RE: EAST TWIN PARK SPLASH PAD PROJECT
S&A PROJECT No. 123.0256

ADDENDUM NO. 1

City of Webster City
East Twin Park Splash Pad Project
Webster City, Iowa
December 29, 2023

Sheet C300

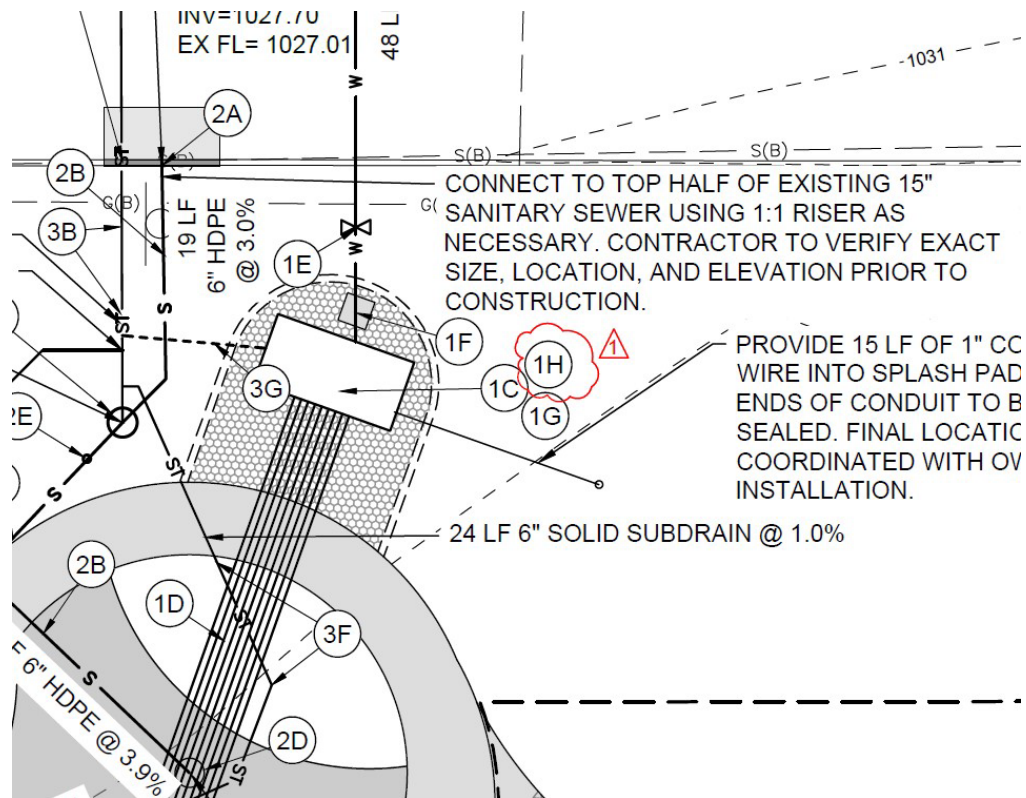
Utility Plan Construction Notes

Add Note 1H with the following:

"1. H. Pressure reducing valve, contractor to furnish and install Watts 2" pressure reducing valve, lead free series LF25AUB-Z3."

TYPICAL PAVEMENT CROSS SECTIONS

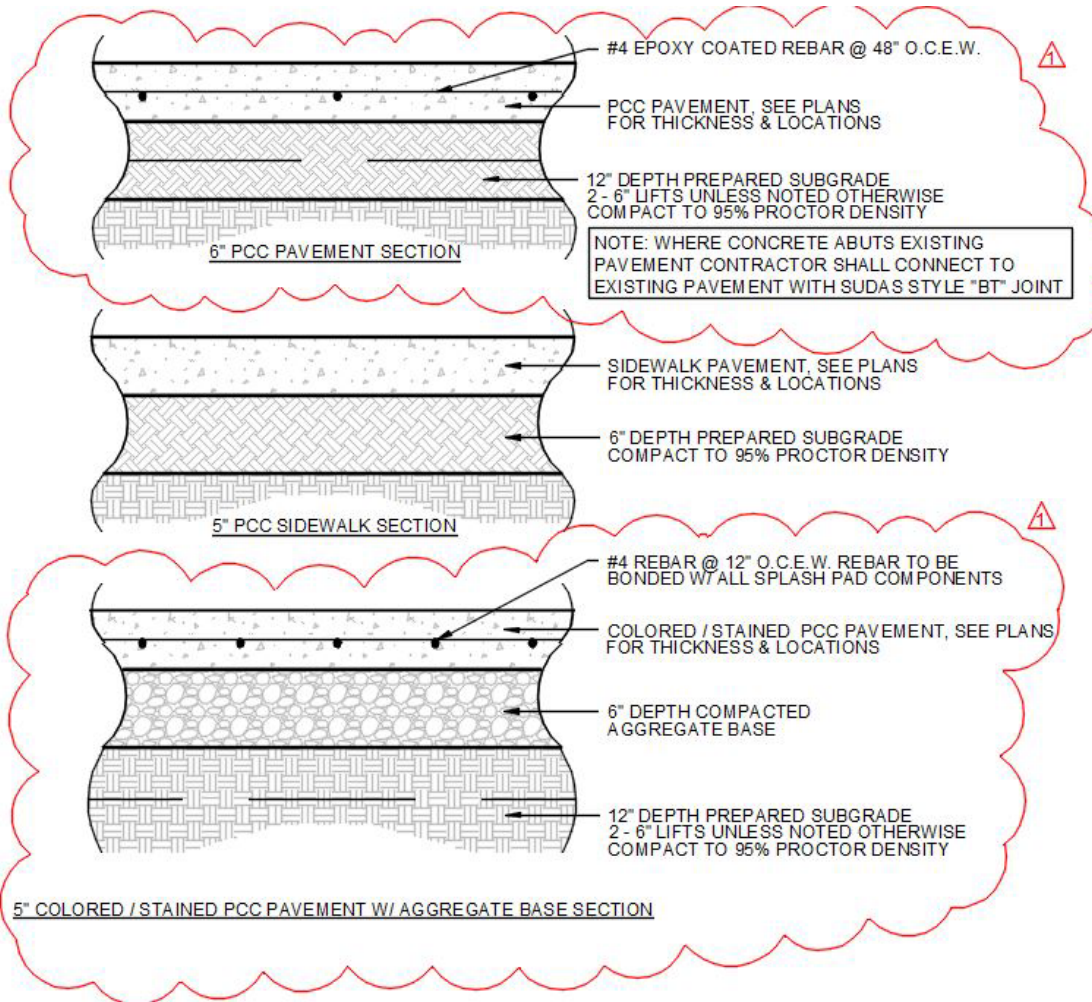
Revise Detail 2 Typical Pavement Cross Sections with the following:

DWG NAME:
WATERPLAY PIPING SCHEMATIC

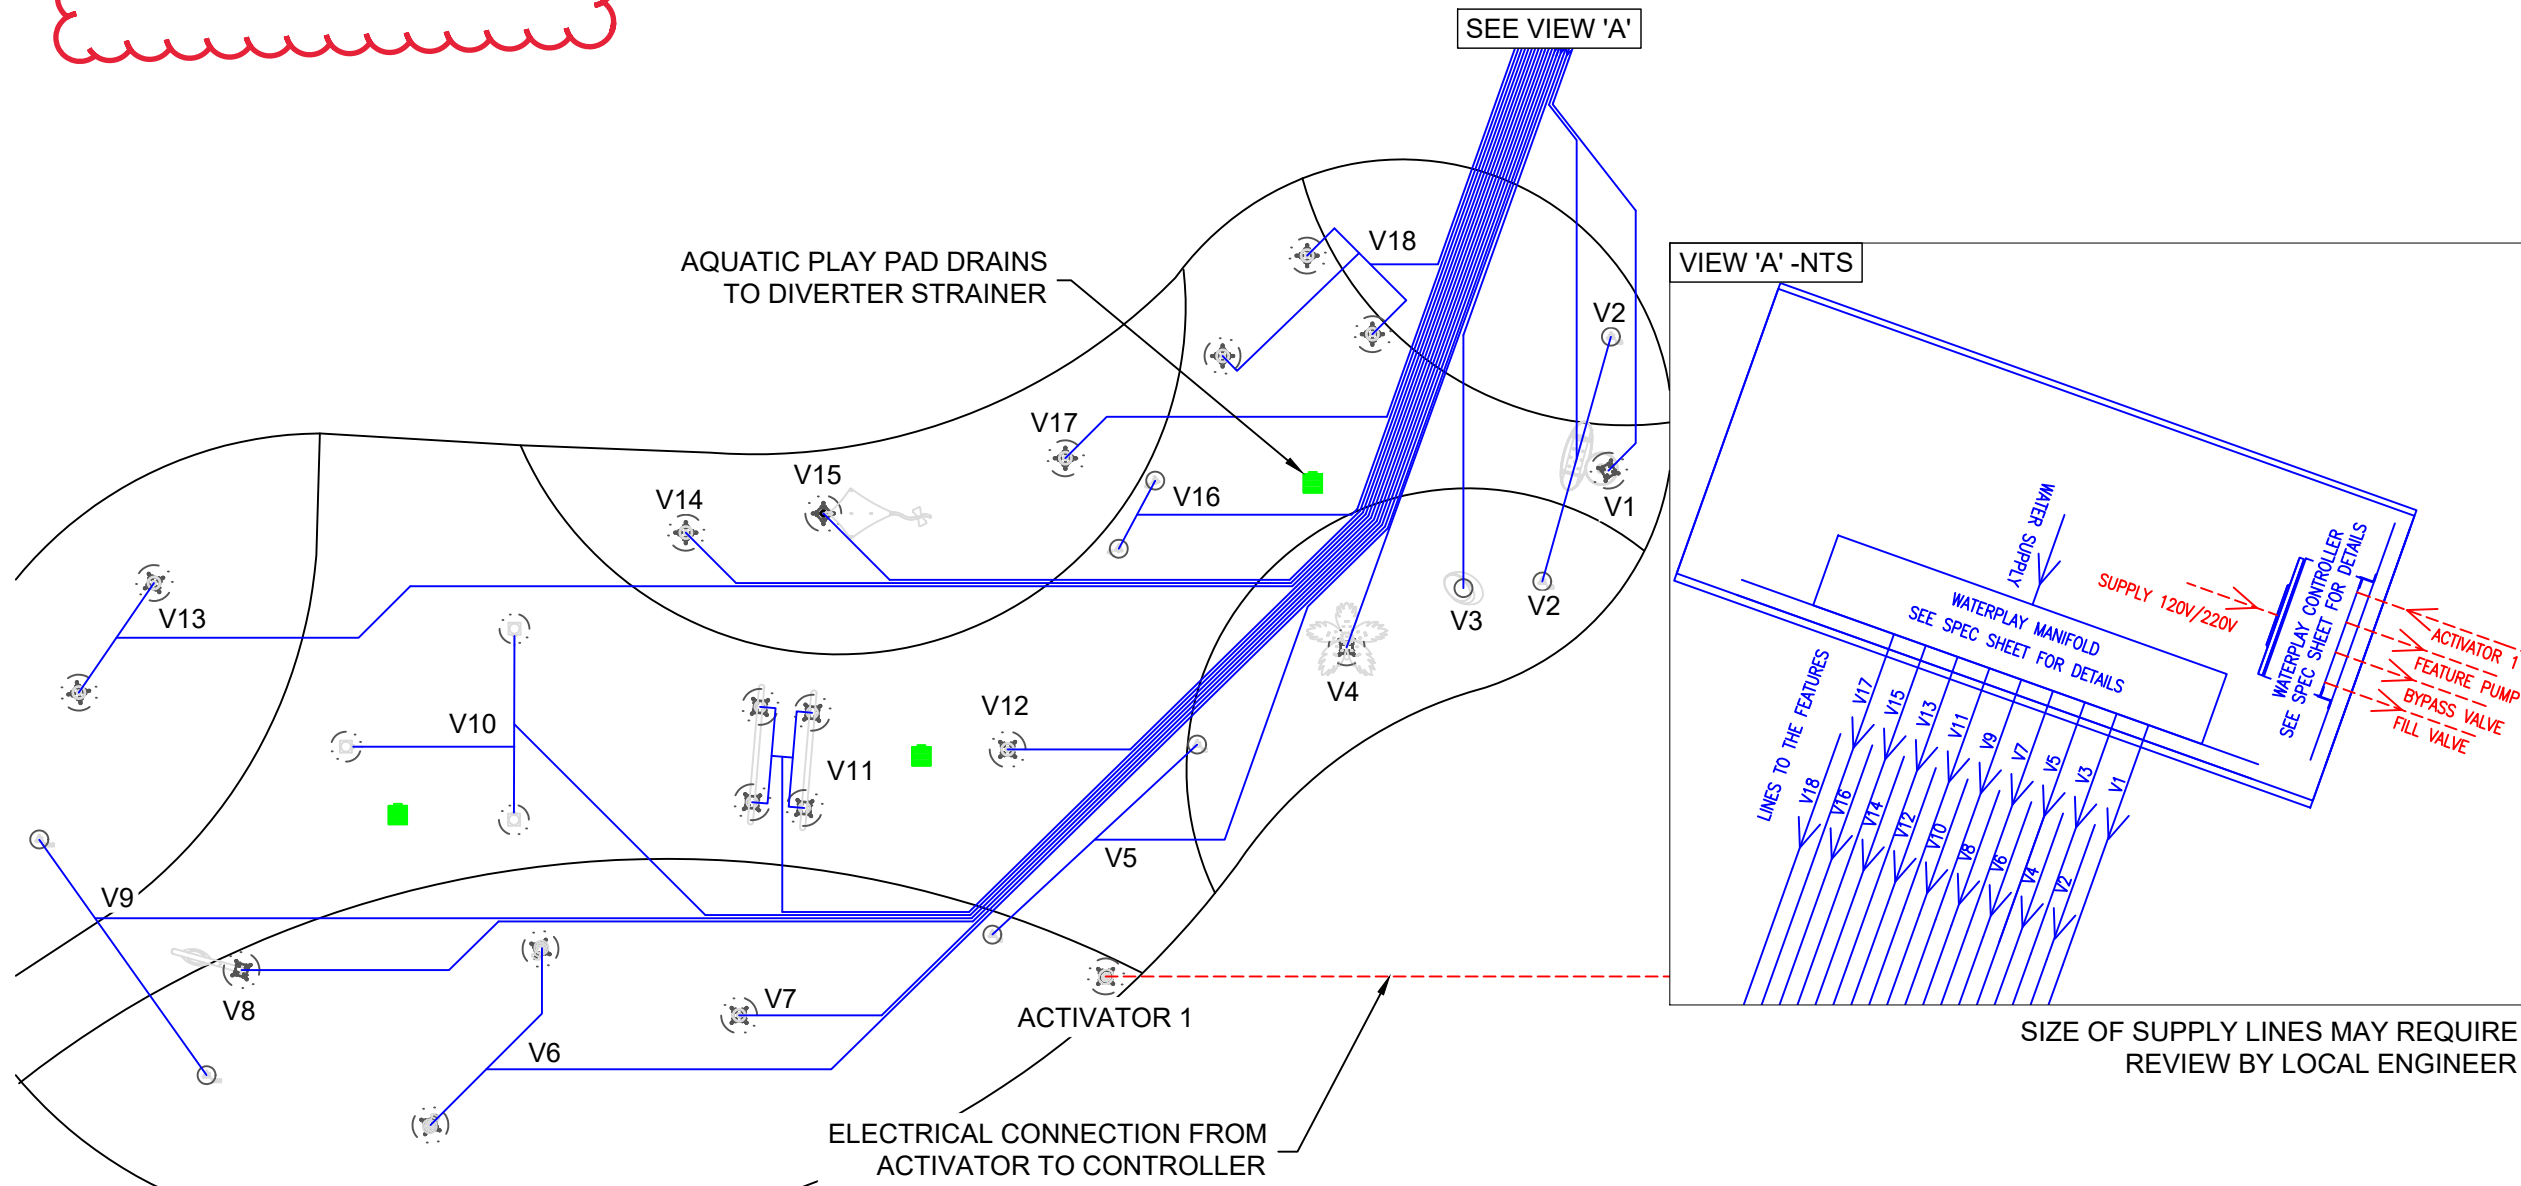
Add Waterplay Pipe Routing Plan to the end of the Construction Plans

See attached plan sheet.
